MHBL Response to INAC Information Request dated 10 May 2004

DORIS NORTH PROJECT
Surface Infrastructure Preliminary Design

PROJECT NO.	DATE	APPROVED	FIGURE
1CM014.02	May. 2004	E.M.R.	5.16A

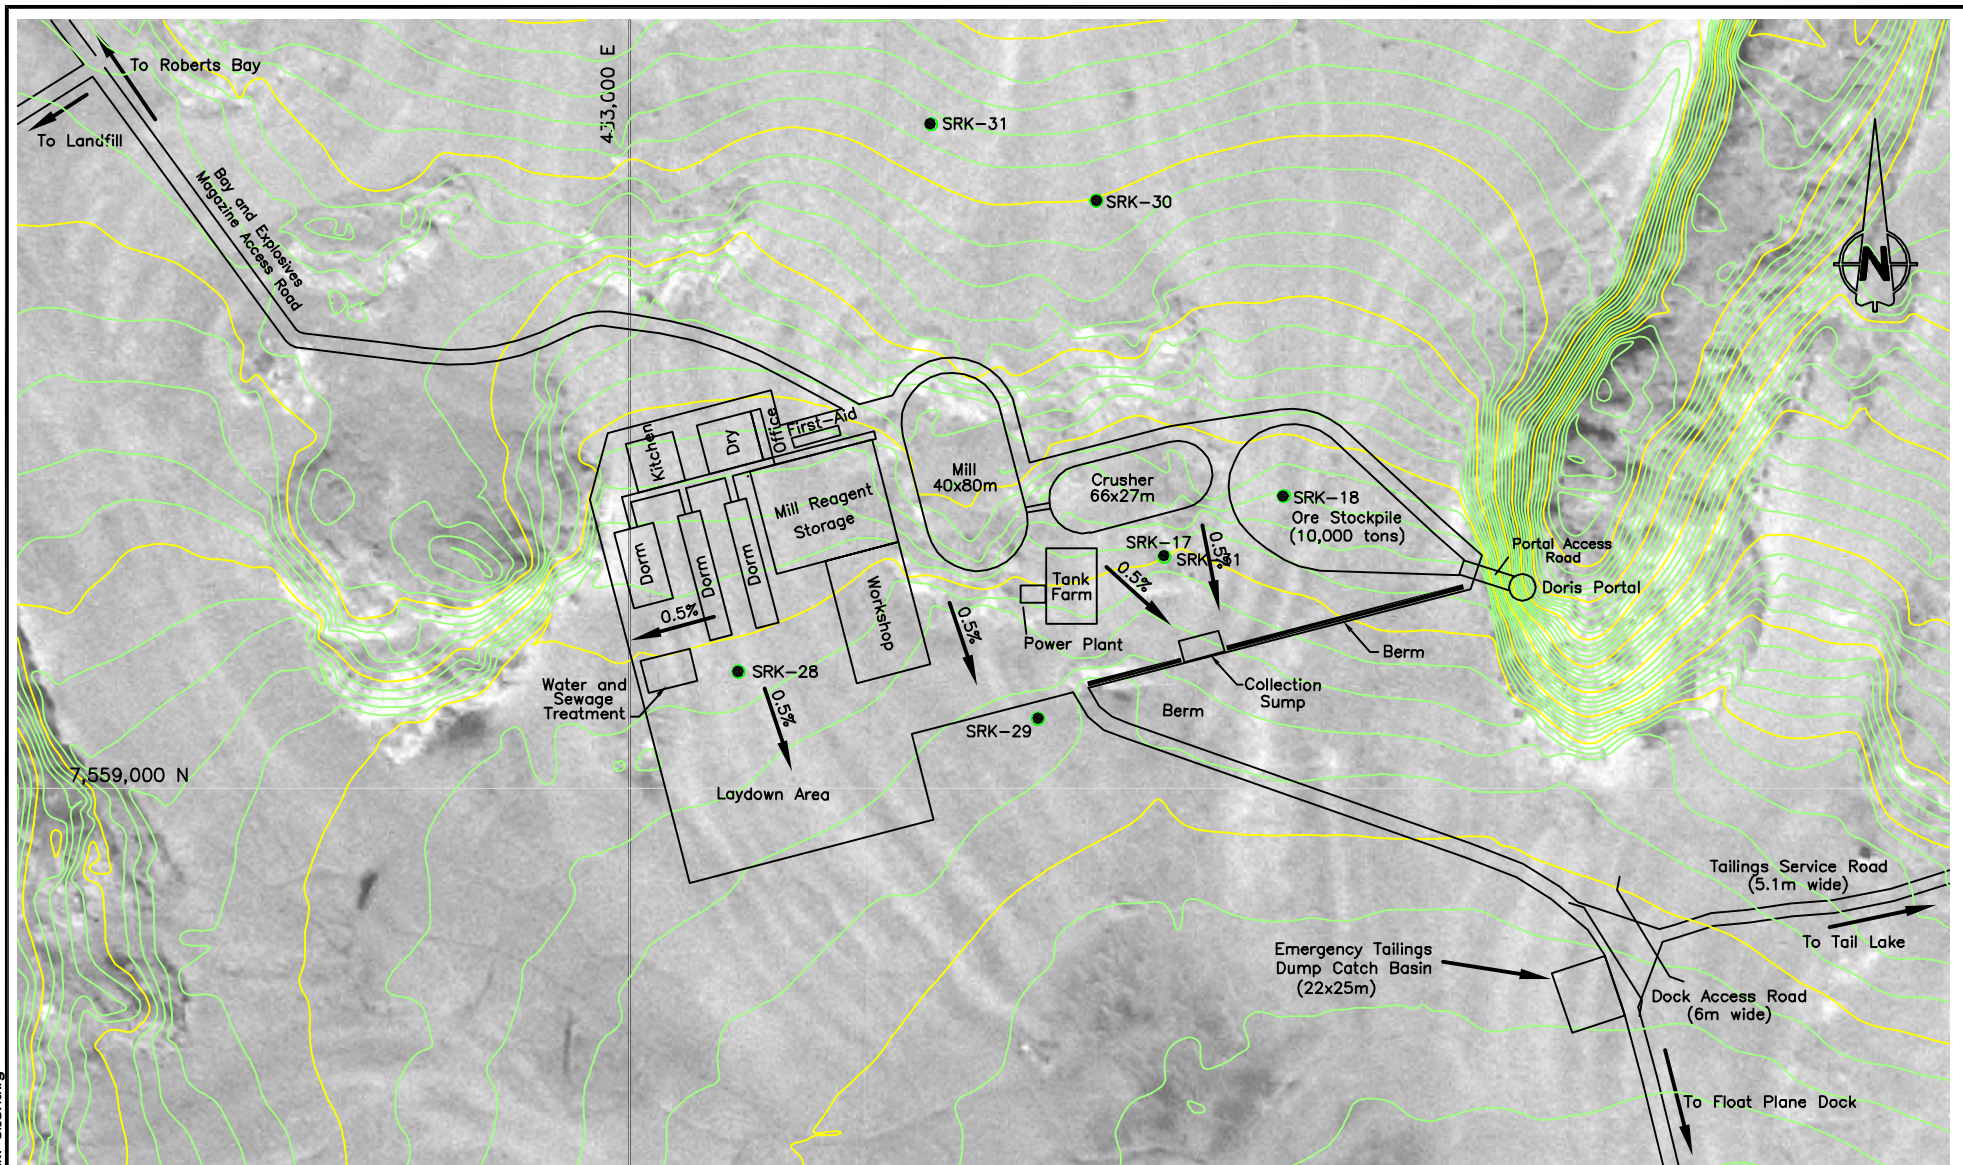
Item 4. Mill foundation conditions

As stated in Supporting Document A4 of the FEIS the preferred foundation condition for the Doris North Project mill is bedrock. Specifically for that purpose, MHBL selected an area of exposed bedrock to place the mill on, and designed the remainder of the camp/mill facilities around this zone. This mill foundation area will be prepared by creating a leveled surface area through precision rock blasting in the exposed bedrock area. Photo 1 below illustrates the outcrop in question, and the attached Figure 5.16A presents an overlay of the mill location with an aerial photograph of the site clearly indicating that the mill will be placed on the outcrop area.

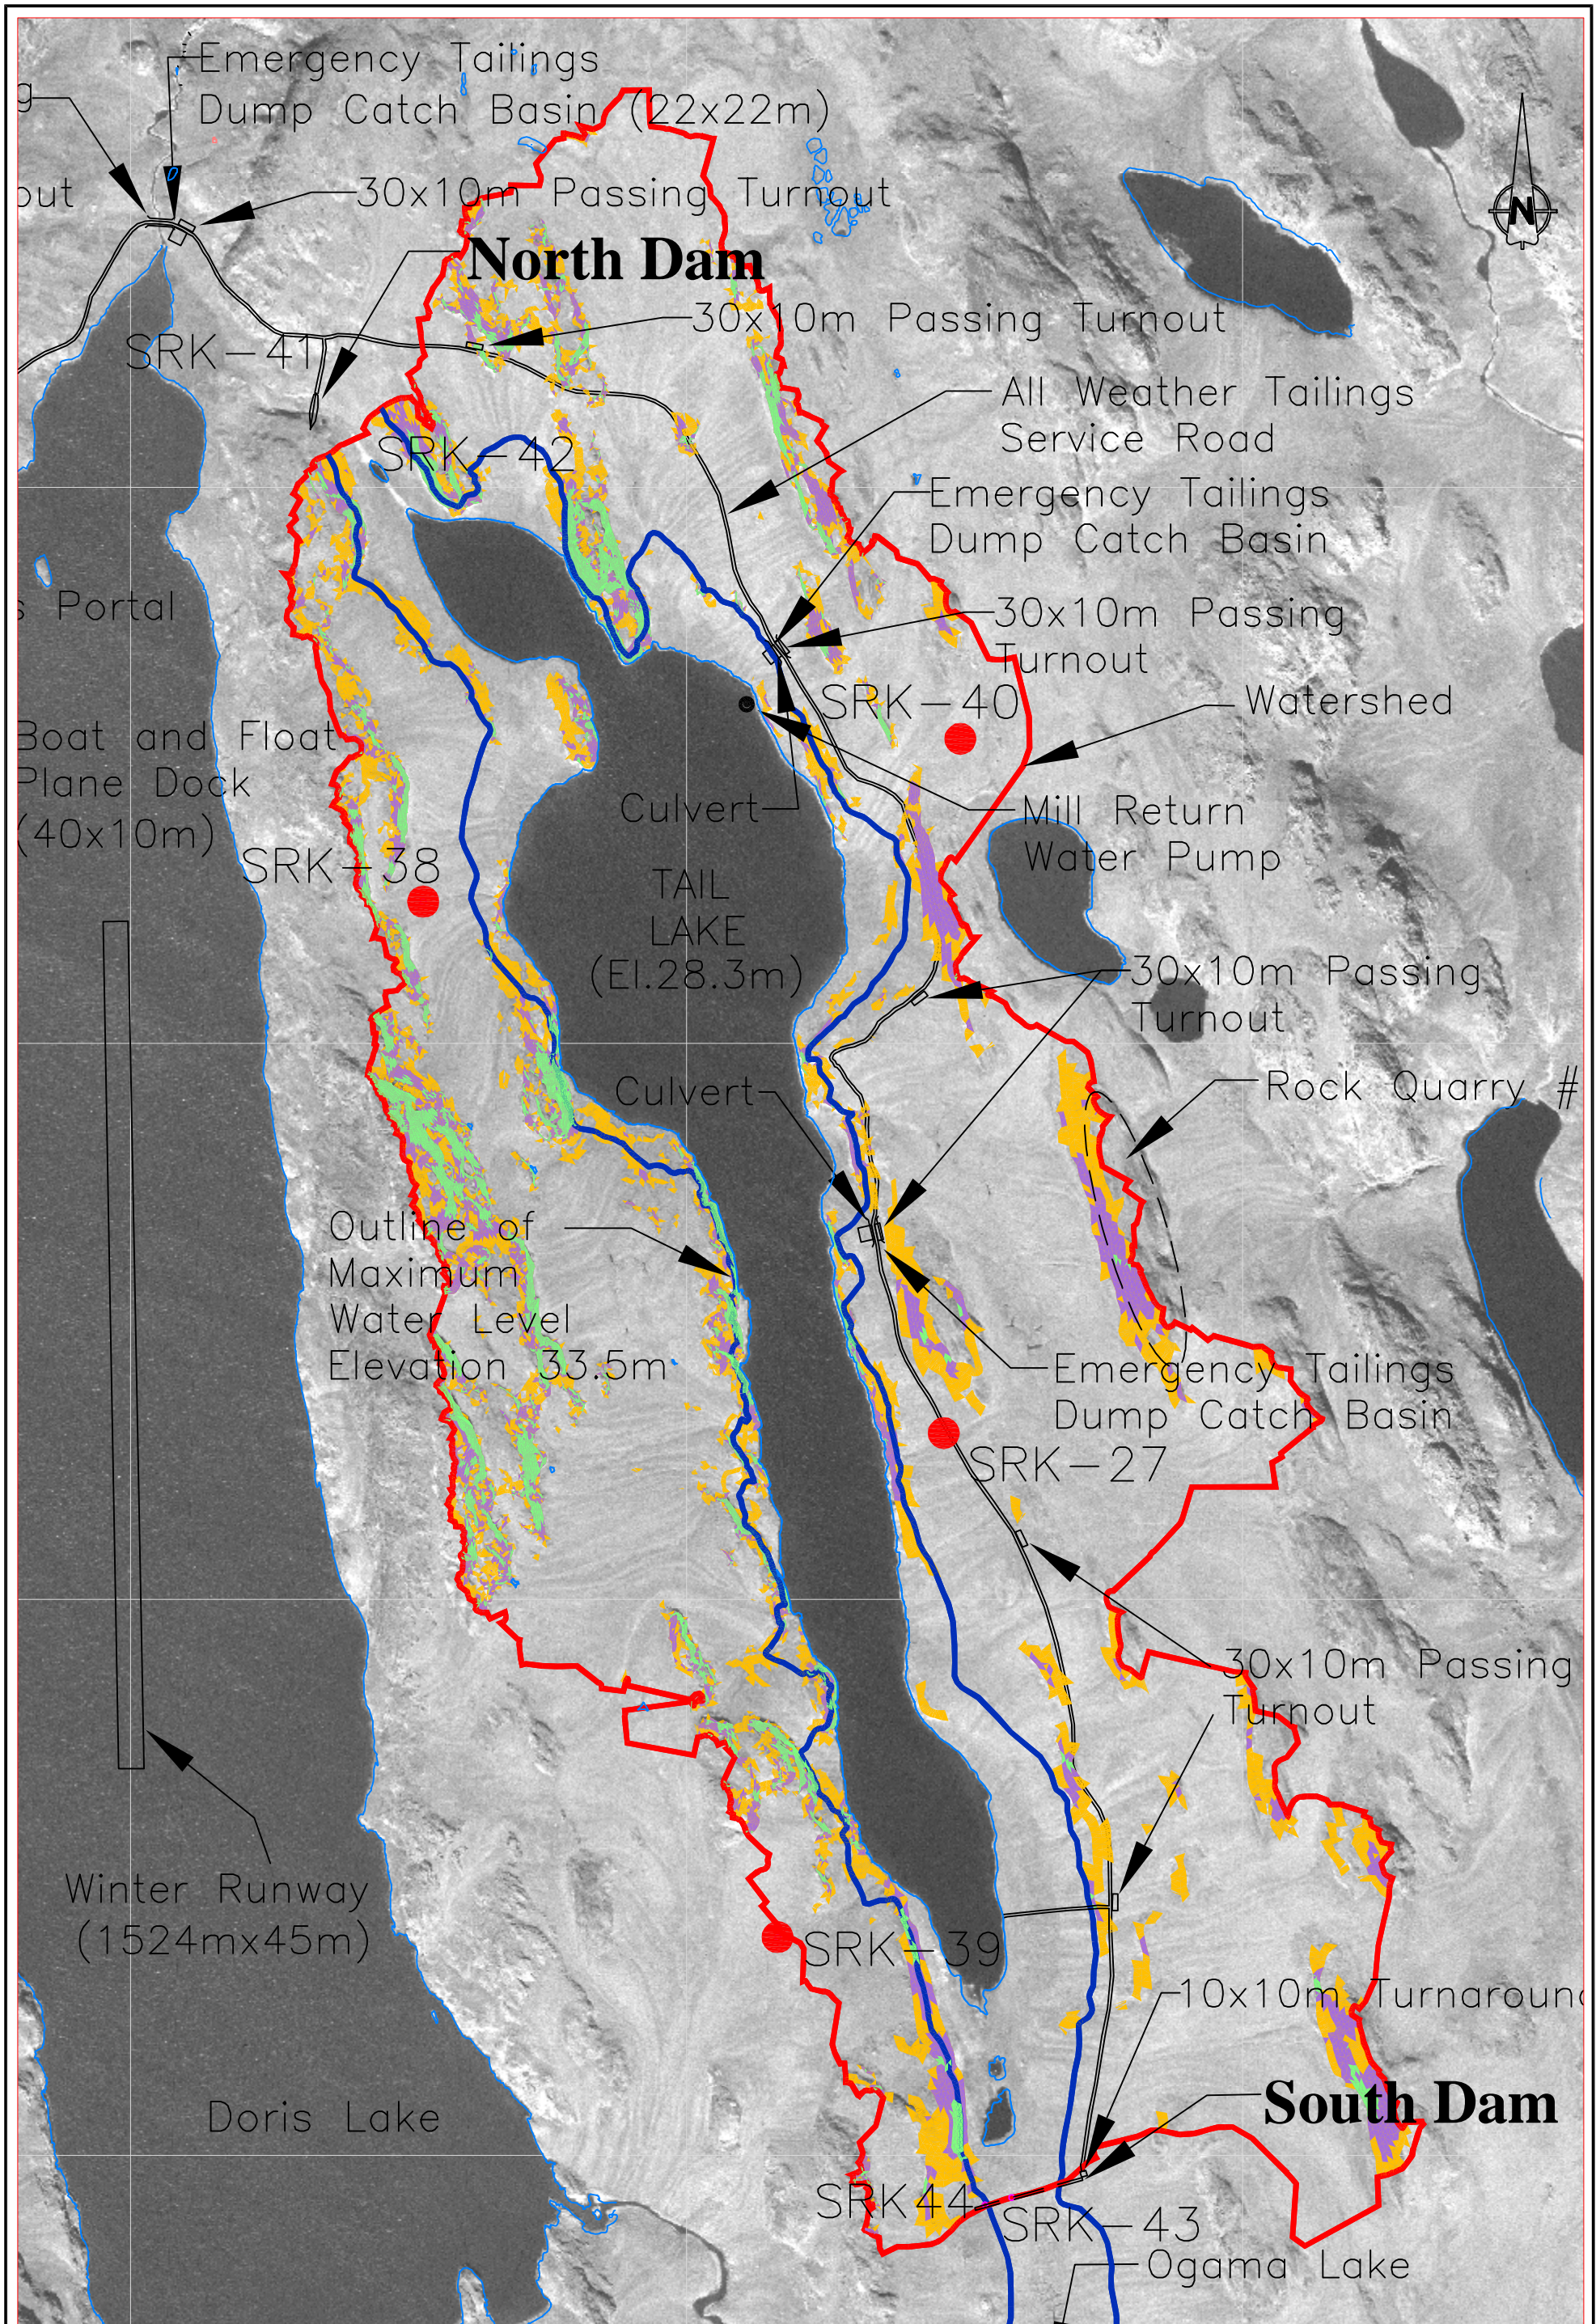
Item 10 – Tail Lake Perimeter Stability

Andersland & Ladanyi (2004) state that in order to minimise the risk of inducing any soil mass movements in permafrost very flat surfaces should be specified (1H:3V or flatter). The attached Figure 1.3A presents a plan view of the Tail Lake catchment area, overlaid on an aerial photograph of the site. The final full supply water level of 33.5m in Tail Lake is shown on the plan together with three different shadings representing slope

angles within the catchment. Any sections within the catchment with slope angles steeper than 6° (1H9.5V) are shaded in yellow; slopes steeper than 11° (1H:5.1V) are shaded in purple and slopes steeper than 18° (1H:3.1V) are shaded in green. Although the raising water level in Tail Lake does not constitute a cut slope, this figure does illustrate that the steep slopes in the catchment are bedrock dominated, and that the permafrost soils are generally flatter than 6° , which substantially reduces the risk of soil mass movements, especially within the area impacted by Tail Lake.
